FED.ROAD REGION	DIVISION	PROJ. NO.	SHEET NO.	SHEET TOTALS
VIII	COLO.	IR 25-2(187)	92	~~170~~ 177

UNIT 1: 3-SPAN (121'-1 1/2", 129'-0", 108'-8 5/8"), F-16-NK
UNIT 2: 4-SPAN (115'-4 5/8", 150'-0", 150'-0", 121'-3"), F-16-OE
EACH UNIT CONTINUOUS POST-TENSIONED CAST-IN-PLACE CONCRETE BOX GIRDER BRIDGE.

GENERAL INFORMATION

Near Denver Sec 9	T4S R68W		
Designer R. KOESTER		Structure Numbers	F-16-NK
Detailer HINSHAW, PANNING			F-16-OE
Drawing Number B-1	of 50	Drawings

SECTION B-3 / A

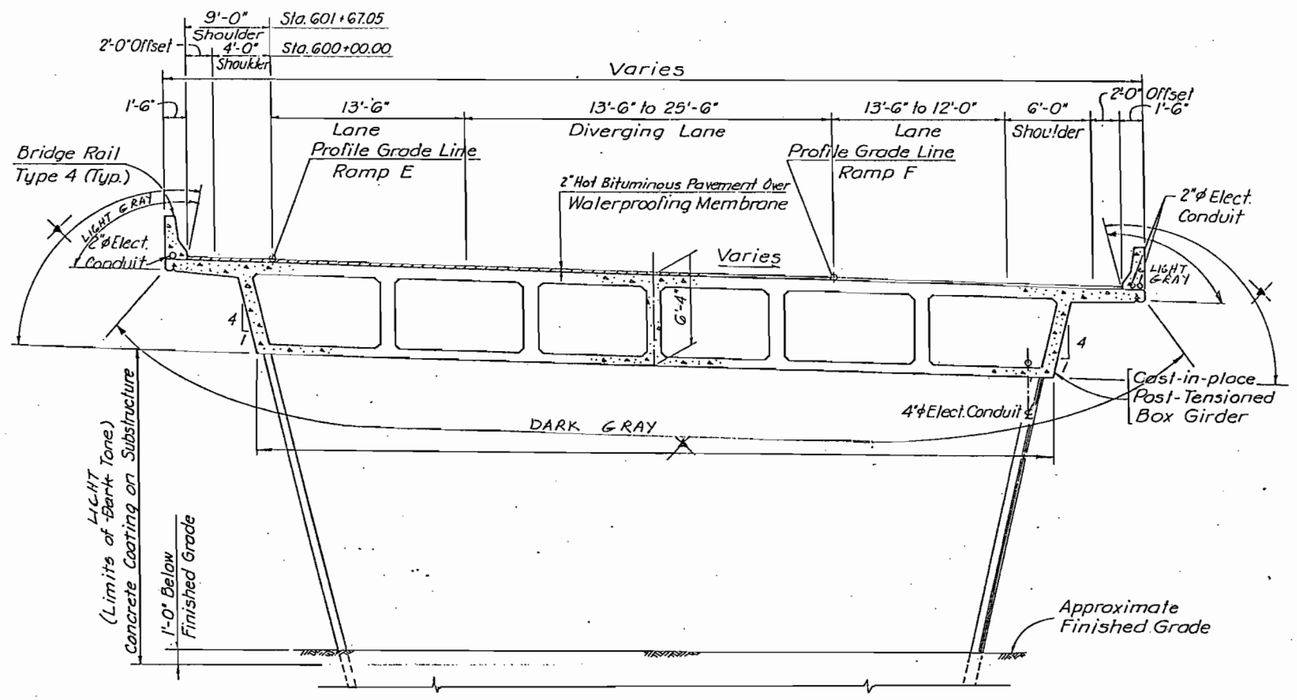
▲ ~~Limits of Light Tone Concrete Coating on Superstructure and Bridge Rail~~

SECTION B-4 / C

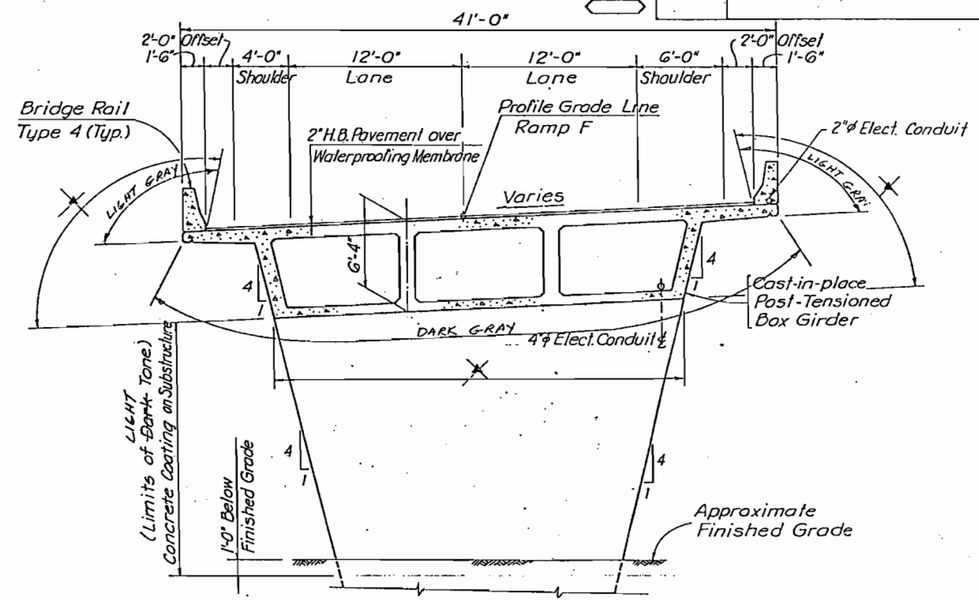
▲ ~~Limits of Light Tone Concrete Coating on Superstructure and Bridge Rail~~

SECTION B-3 / B

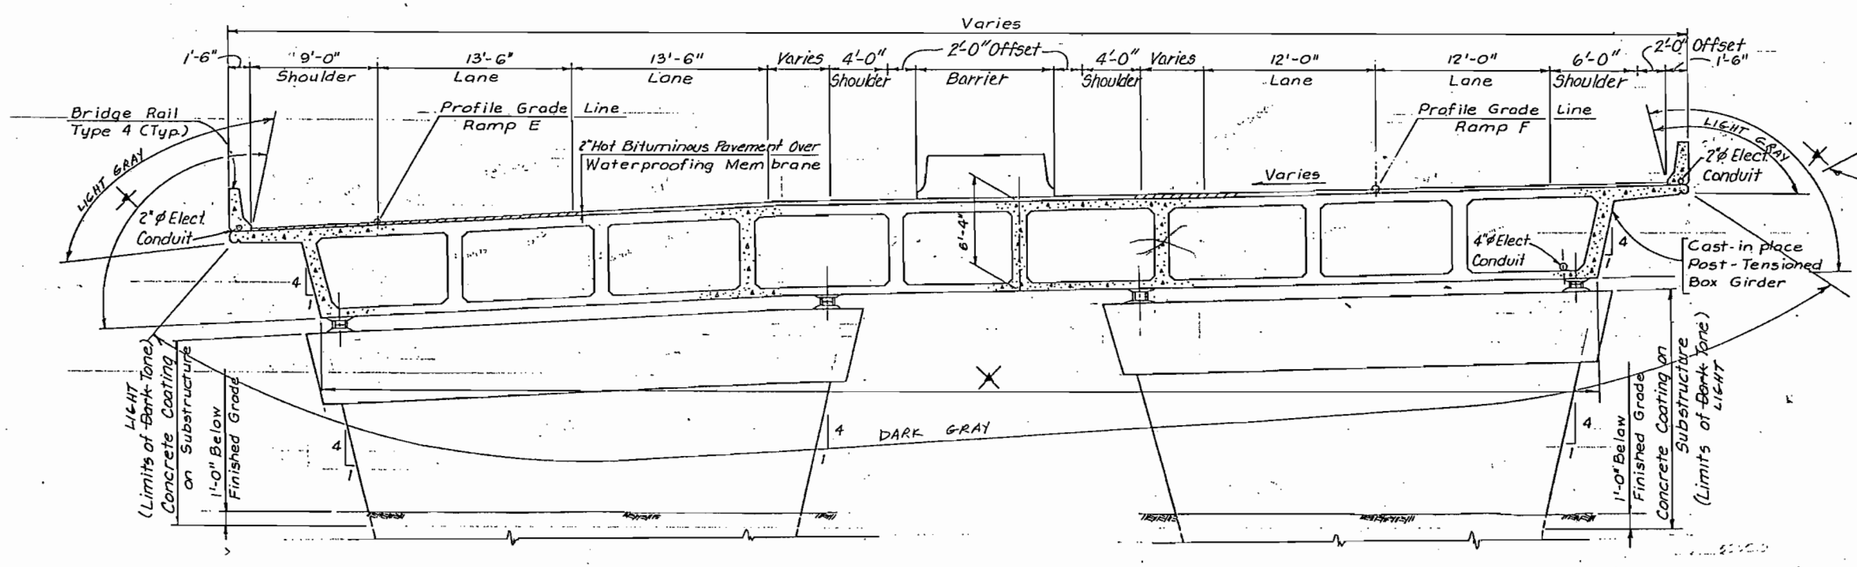
▲ ~~Limits of Light Tone Concrete Coating on Superstructure Bridge Rail~~
